Ref: FCC Class II Permissive change for FCC ID: QDS-BRCM1019
Applicant: Broadcom Corporation

Pursuant to Section 2.1043 of the FCC rules, we hereby request a Class II permissive change for FCC ID: QDS-BRCM1019, originally granted on 11/30/2005.

BCM94311MCAG

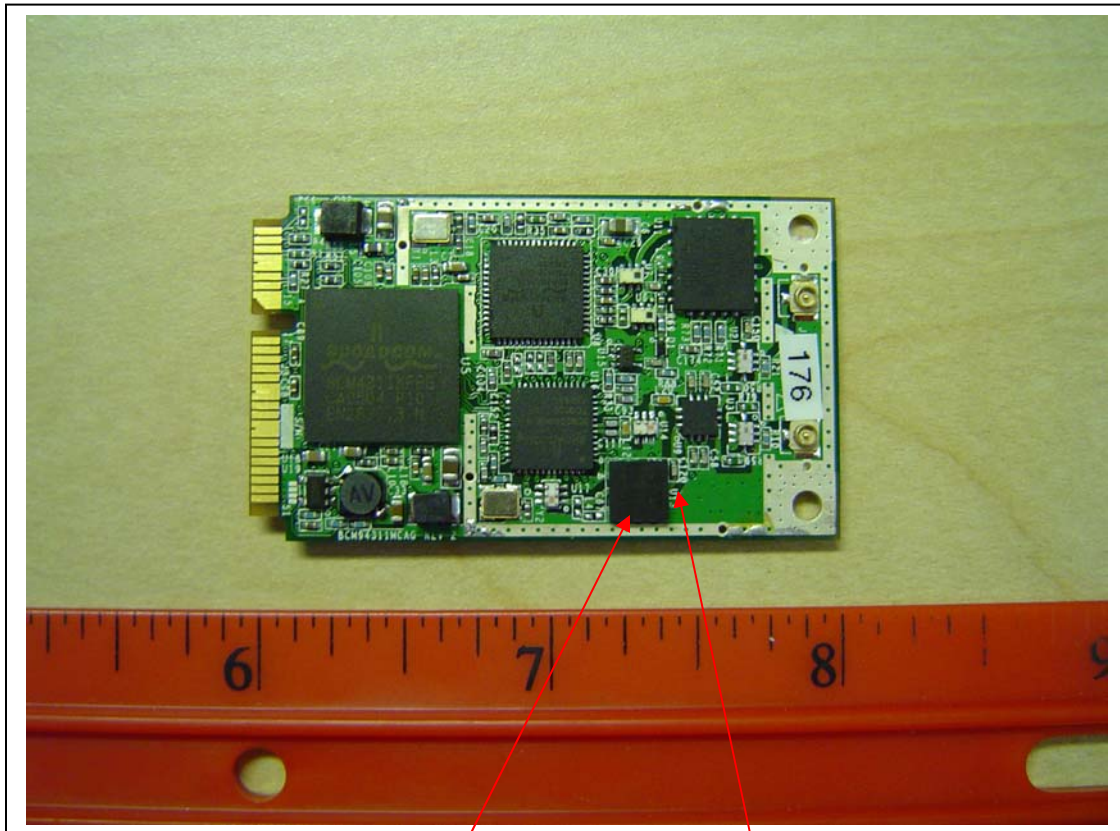
Change #1 The 5GHz power amp has been modified from a Fairchild to a Micromobio model and the associated layout and filter circuitry is slightly different. The output powers remain the same.

Alternate PA

A pad is added
